Environmental Evaluation of Accident Tolerant Fuels with Increased Enrichment and Higher Burnup Levels

Draft NUREG: Environmental Evaluation of Accident Tolerant Fuels With Increased Enrichment and Higher Burnup Levels

NUREG 2266 COMMENTS

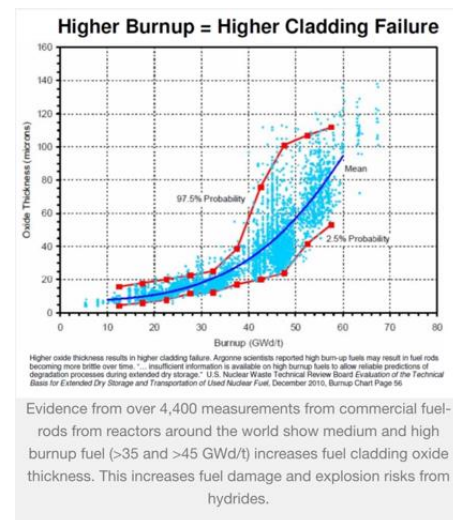
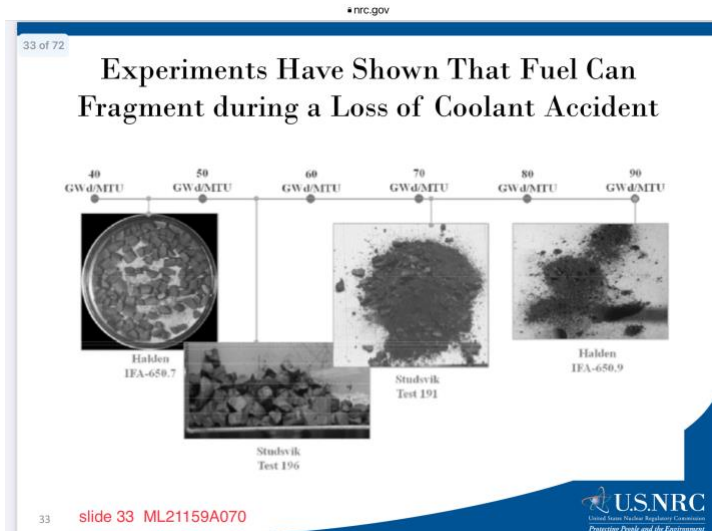
The NRC has never provided a technical response to evidence of explosion risks with a breached canister. ML18269A037
